11801 SEVEN LOCKS ROAD, WILLERBURN ACRES, SECTION 2

PRELIMINARY PLAN NO. 120210160

No. 120210160

1-20-2022

Figure 5 - Right-of-way dedication to provide truncation at Seven Locks Road and Fontaine Street

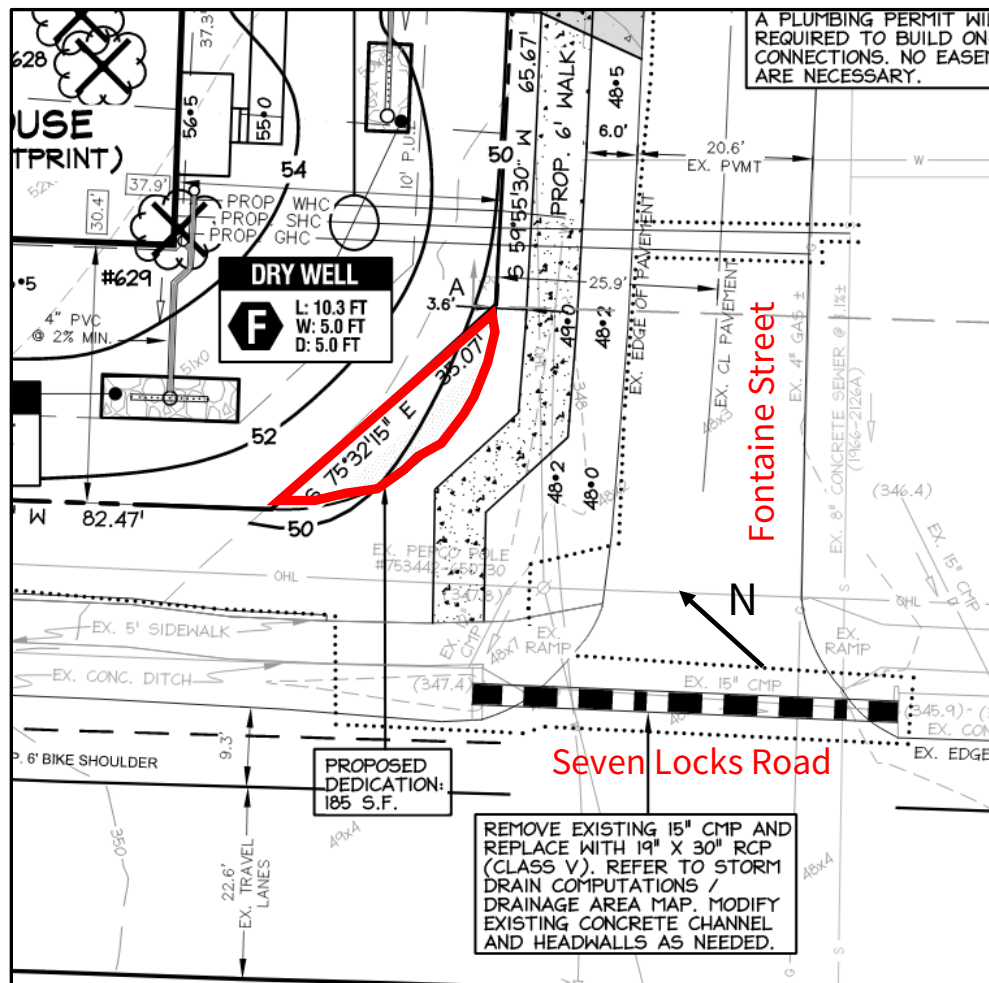
MCDOT standards in order to provide adequate room for utilities and pedestrians to navigate the corner (Figure 5).

- a. The truncated corner of right-of-way consistent with MCDOT standards at the intersection of Seven Locks Road and Fontaine Street as shown on the Certified Preliminary Plan.

Figure 6 – Protected Trees to be Removed and Mitigation Plantings

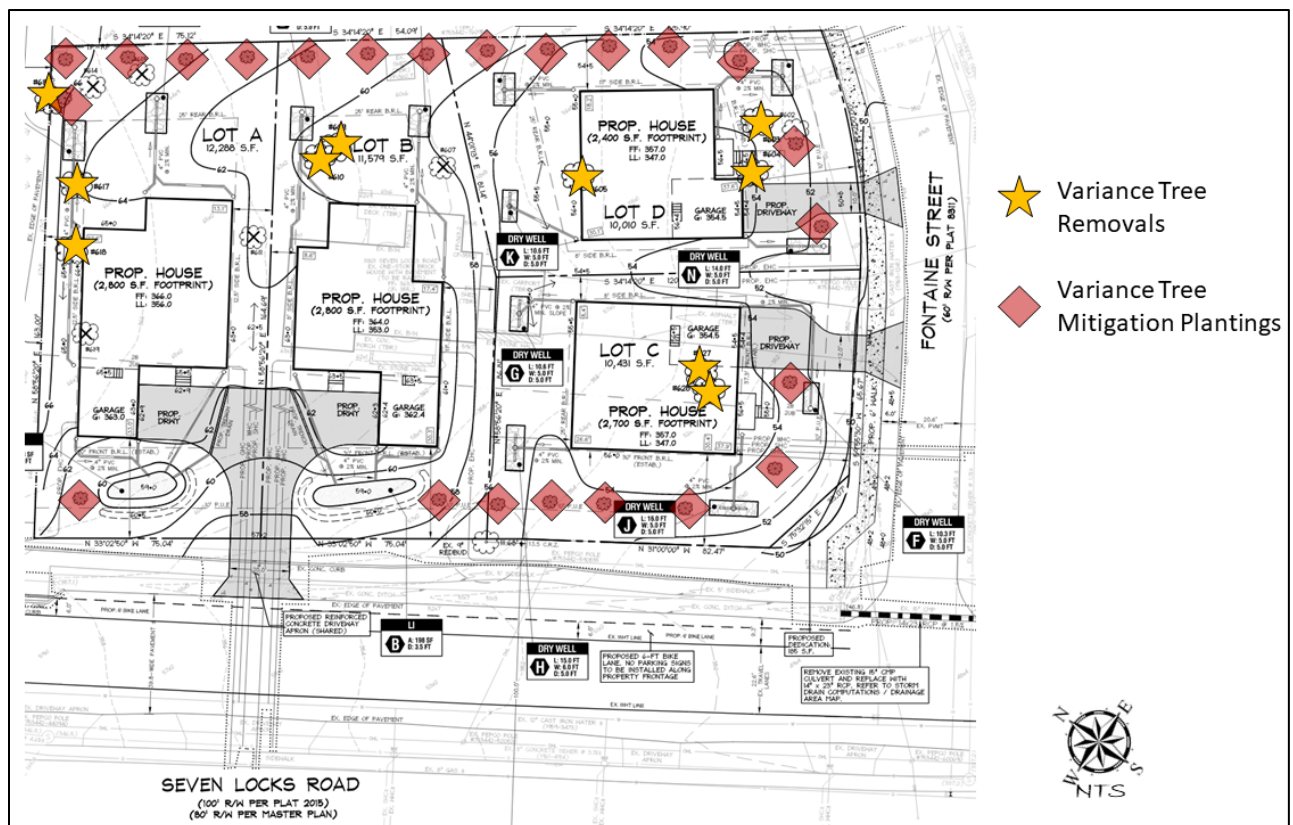
The Applicant submitted a variance request in a letter dated September 1, 2021 (Attachment 7) seeking a variance from Section 22A-12(b)(3) of the FCL. The Applicant proposes to remove ten (10) trees that are 30 inches or greater DBH, that are considered high priority for retention under Section 22A-12(b)(3) of the FCL (Figure 6).

There are 10 trees proposed for removal in this variance request resulting in a total of 364 inches of DBH being removed. These 10 trees being removed are not located within an existing forest stand on the Subject Property. The Applicant has proposed to provide mitigation for the specimen tree loss by replacing the total number of DBH removed with $\frac{1}{4}$ of the amount of inches replanted. This results in a total mitigation of 92 inches of replanted trees. In this case, the Applicant proposes to plant 23 four inch caliper overstory trees native to the Piedmont Region of Maryland on the Property outside of any rights-of-way and outside of any utility easements as shown on the FFCP.

- f. The Applicant must plant the variance tree mitigation plantings on the Subject Property with a minimum size of 4 caliper inches totaling 92 caliper inches as shown on the approved FFCP. Adjustments to the planting locations of these trees is permitted with the approval of the M-NCPPC Forest Conservation Inspection Staff.

11801 Seven Locks Road Lot 1, Block C Willerburn Acres, Section 2 Proposed Lots A - D Fire Department Access Plan

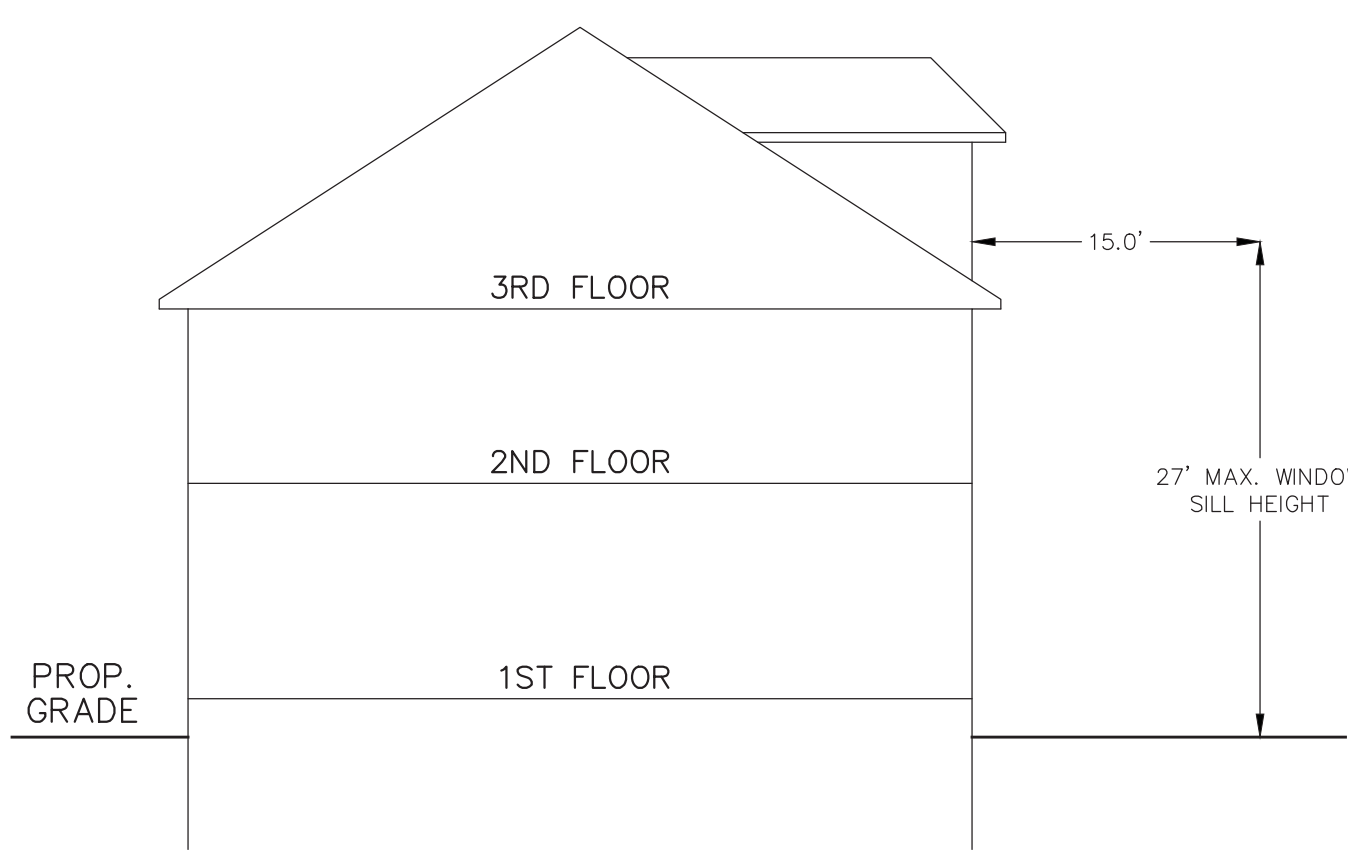
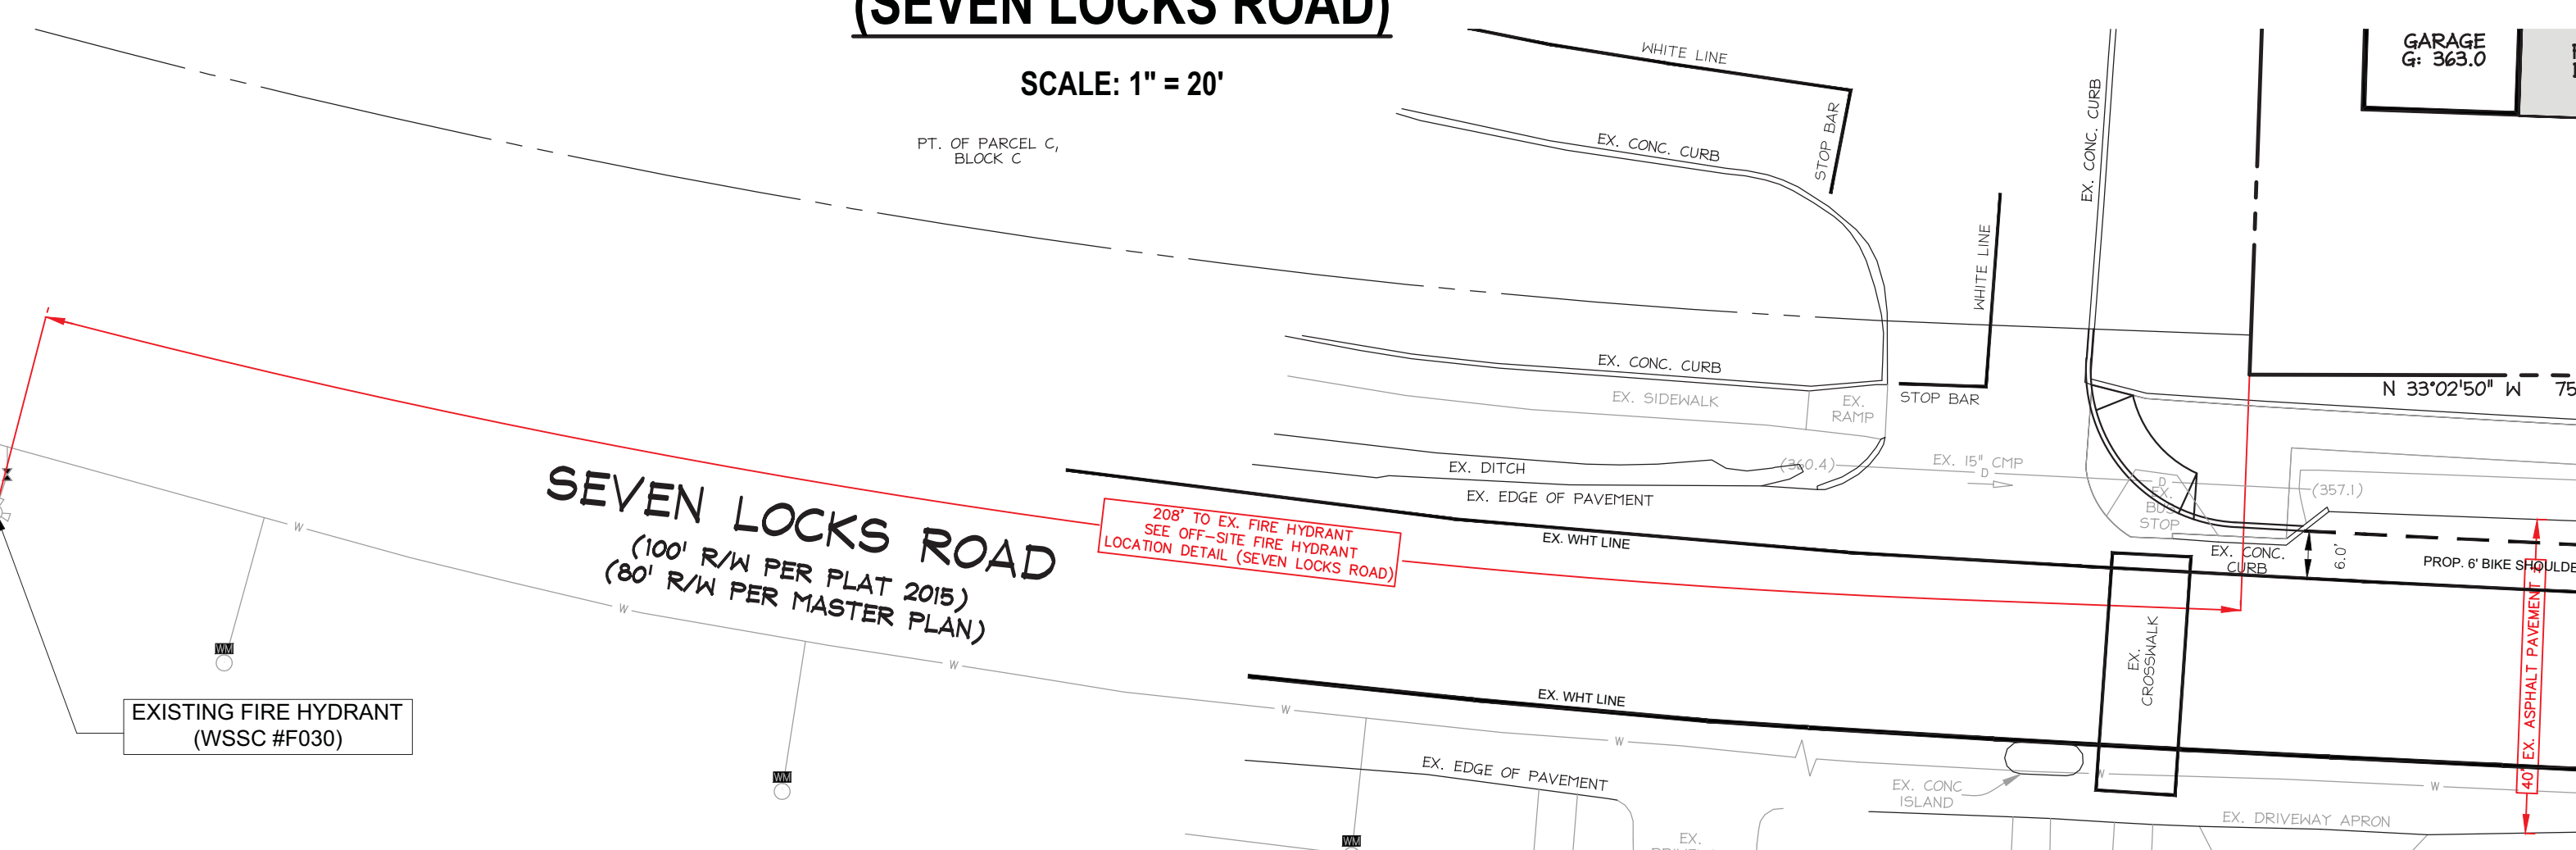
PROPOSED HOUSES ARE SUBJECT TO HEIGHT RESTRICTIONS WHERE THE MAXIMUM WINDOW HEIGHT ON THE 3RD FLOOR (OR UPPER HALF STORY, INCLUDING FALSE DORMERS) IS LIMITED TO 27-FEET ABOVE GRADE, AS MEASURED 15-FT FROM THE HOUSE. (SEE DETAIL THIS SHEET)
